**ALLSTAR PZL GLIDER**

## SERVICE BULLETIN BE-004/54-2/2026

- SAILPLANE:** Type SZD-54 „Perkoz”, model SZD-54-2 „Perkoz”.
- SERIAL NUMBERS  
AFFECTED:** All sailplanes of the SZD-54 "Perkoz" type, model SZD-54-2 "Perkoz", up to and including serial number 542.A.25.049.
- SUBJECT:**
1. Inspection of the airbrake driving torsional tube.
  2. Procedure to follow if damage to the torsional tube is detected.
- COMPLIANCE  
TIME:** Upon receipt of this Service Bulletin.

Figure 1 – location of the torsion tube (3) of the airbrake drive in the fuselage.  
The arrows indicate the areas being checked, shown in more detail in Figure 2.

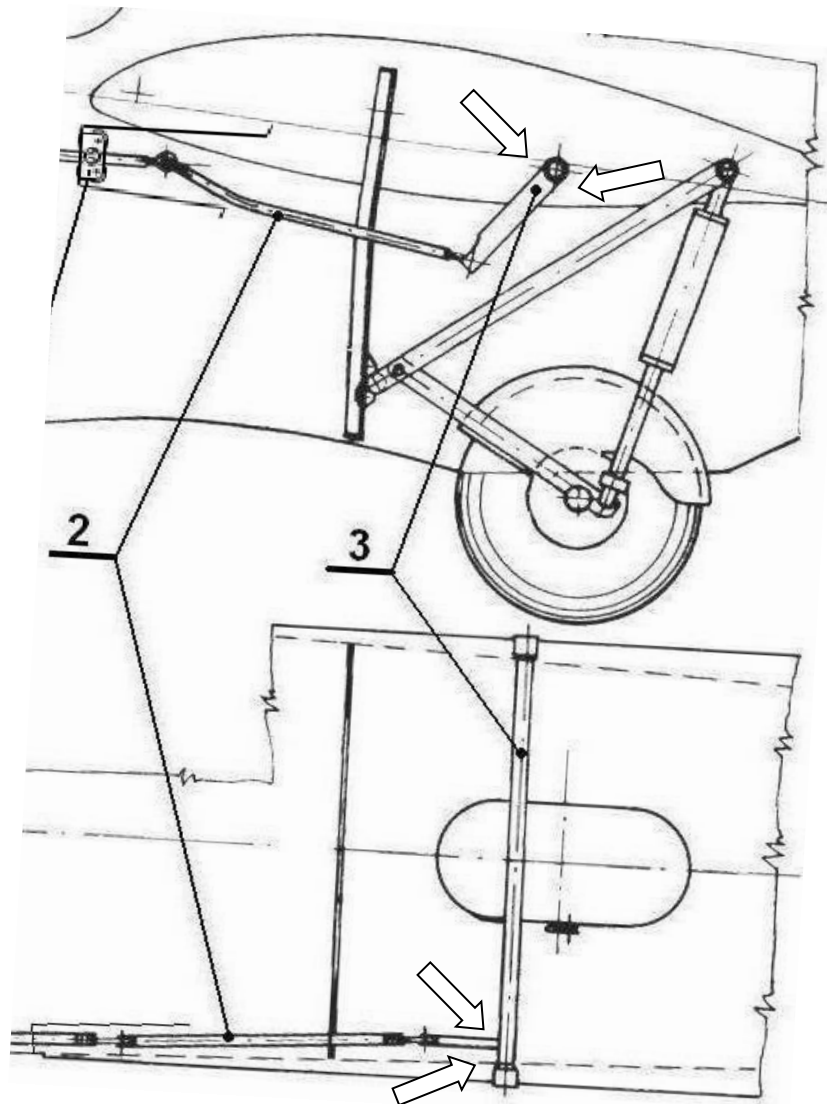
1 | Cracks or permanent deformation of the tube and lever (in the area where these components join) or cracks of the welds are not permitted (Figures 1 and 2).

- 3.1.1. Remove the wings according to the procedure described in the Technical Service Manual, section 2.1, or the Flight Manual, section 4.
- 3.1.2. Using a mirror and a strong light source (flashlight), visually inspect the area where the lever is welded to the torsional tube (item 3 in Figure 1 and the areas susceptible to cracking, as indicated in Figure 2).
- 3.1.3. After inspection, reassemble the wings according to the procedure described in the Technical Service Manual, Section 2.1, or the Flight Manual, Section 4.

- 4.1. If any damage is found, the torsion tube must be replaced with a **new one featuring reinforcements** (consistent with the EASA Major Change Approval No. 10090201).
- 4.2. Once the damaged torsion tube has been replaced with a new, reinforced one, the inspections described in points 3.1 and 3.2 **are not required**; however, the provisions of the Technical Maintenance Manual, Chapter 16, remain in force.
- 4.3. If the inspection reveals no damage to the connection between the lever and the torsion tube (non-reinforced version), the glider may continue to be operated, provided that the inspections described in points 3.1 and 3.2 are carried out in accordance with the inspection intervals set out in point 3.3.

Figure 2 – connection of the lever to the torsional tube of the airbrake control with indication of areas where cracks may appear (on both sides).

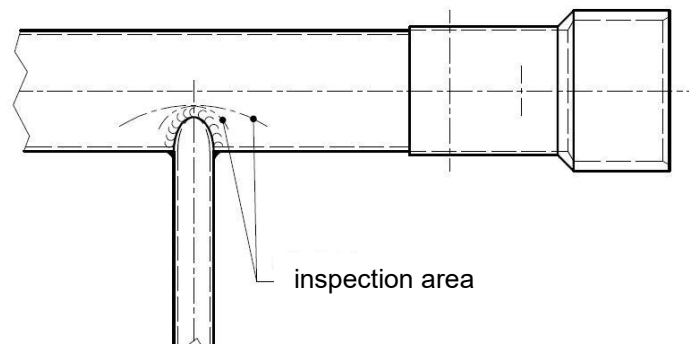
- 3.2.1. With the wings and rear baggage compartment floor removed, remove the airbrake drive torsional tube assembly.
- 3.2.2. Using a magnifying glass with at least 3x magnification, inspect that there are no cracks in the weld area and around the welded lever-tube joint (Figure 2).
- 3.2.3. If necessary, perform defectoscopy of the areas to be checked - Dye Penetrant Inspection (DPI).
- 3.2.4. Visually check that the tube has retained its cylindrical shape and that there are no permanent deformations.
